III. THE HATFIELD MODEL VIOLATES STANDARD ECONOMIC PRINCIPLES

V. THE HATFIELD MODEL VIOLATES STANDARD ENGINEERING PRACTICES AND UNDERSTATES ASSOCIATED COSTS

Figure 2⁷⁶
HM 3.0, 3.1 and 4.0 Distribution Architecture

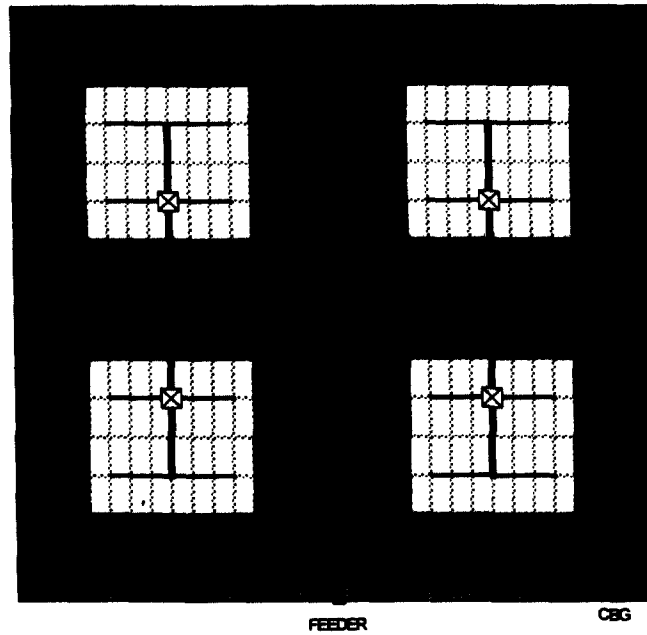
As illustrated above, connecting cable runs from the center of the distribution area (which coincides with the location of the SAI, in case of copper connecting cable) into each of the four

quadrants. From there, backbone cables run in the north-south direction down the middle of each quadrant. Finally, branch cables run in the east-west direction from each of the branch cables.

Applying the "window-pane" methodology to a distribution area of 128 locations results in the following cable statistics.⁷⁷

In HM 5.0, the SAI is also in the center of the distribution area. Two backbone cables run north-south from there in opposite directions. From each of the backbone cables run branch cables in the east-west direction.

In effect, HM 5.0 has replaced the four connecting/backbone cables with two larger (more pairs) cables and has connected the branch cables in adjacent quadrants. As a result, there are fewer route feet and larger cables (which tends to lower the per pair cost of cable). As a result, HM 5.0 lowers total cost by about 15 percent in this example.

What is significant about this example is that in its various incarnations, the Model's supporters have claimed that they are employing classic engineering design, informed by the many years of experience of the engineering team. Yet, between successive versions of the Model, the engineering of comparable situations can change in ways that substantially changes costs, often in a downward direction.⁸⁰
